Site Accessibility Evaluation

CSPD Impound Lot

**1353 S 8th St
Colorado Springs, CO
80905**

SUBJECT: CSPD/Impound Lot Self-Evaluation

Finding 182901 Main Photo

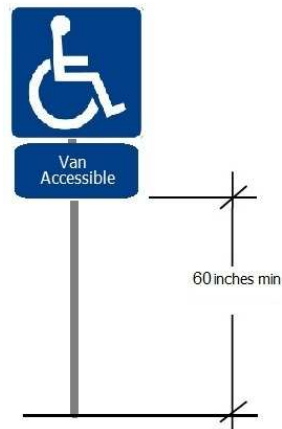
The parking sign is mounted too low.

The three signs are mounted at 58" to the bottom edge (none are van accessible).

Raise existing signs so they are 60 inches minimum above the ground surface.

Add van access sign to the far left parking space closest to the door.

Finding 182902 Main Photo

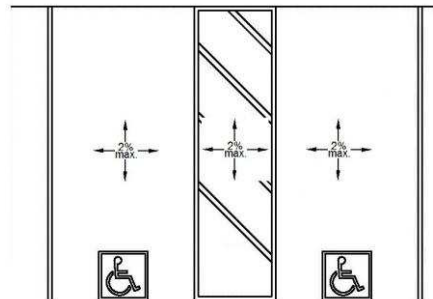
The cross slopes (narrow dimension) and/or running slopes (long dimension) of the accessible stall exceeds 2%.

40' long x 4' wide across the parking spaces and access aisles running slopes as high as 3%.

Correct the cross slope of the stalls to 2% or less.

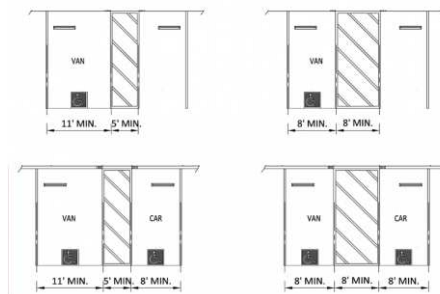
The accessible parking stall is not wide enough.

Accessible parking space on the right is 7'6"

Re-stripe parking space.

Finding 182926 Main Photo

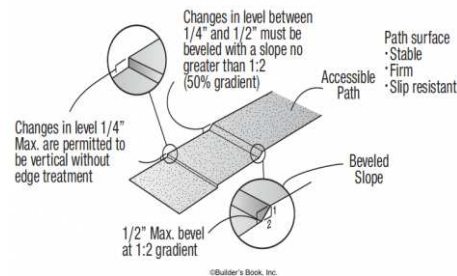
The accessible route contains loose gravel and/or surfaces that do not provide for a stable, firm slip resistant surface.

Pick-up area surface
not firm, stable, or
slip resistant.

Pave concrete pad adjacent to walkway to allow ample space for pick-up.

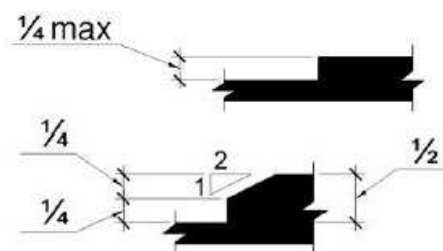
The walkway contains abrupt vertical edges and/or variations over a 1/4 inch.

There are areas of vertical displacement up to 2" where the concrete meets the loose fill

Connect the sidewalk to the future concrete pad where customers will pick up vehicles

Finding 182927 Main Photo

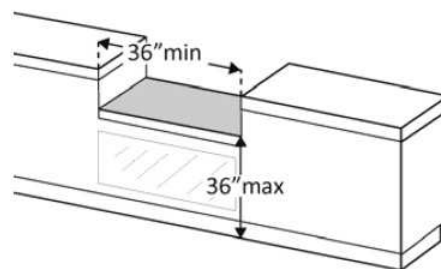
The transaction counter is too high.

Customer service access 42" above floor grade.

Lower security window 6-8". The reach range is OK and the line of sight is marginally alright.

Until counter is corrected, staff must be ready, willing, and able to provide service at an alternate, accessible location.

Finding 182929 Main Photo

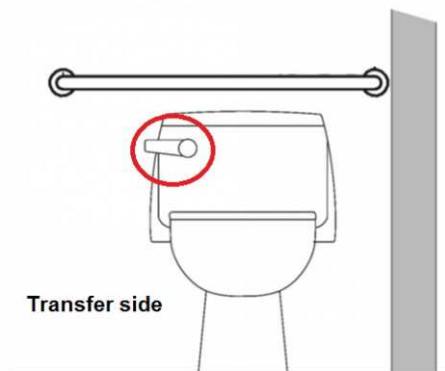
The flush handle is located on the wrong side of the toilet.

Flush is on the closed side.

Move the flush to open side (this will require obtaining another tank).

Finding 182930 Main Photo

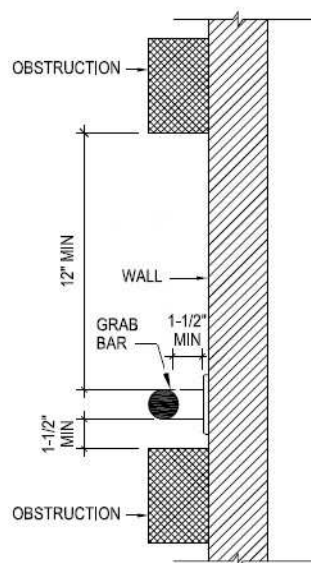
The grab bar is not spaced correctly to the wall or other elements.

Toilet seat covers are only 3.5" above the bar.

Move the toilet seat covers to 1.5" below the grab bar.

Finding 182931 Main Photo

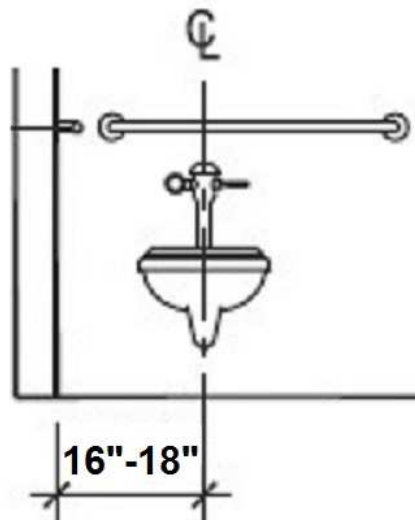
The toilet is not located within the range allowed from the side wall or partition.

The toilet is 1/2" too far from the wall at 18.5" to the centerline of the toilet.

Move toilet over 1/2"+, (use flange) if feasible. If not the wall can be moved over the same distance
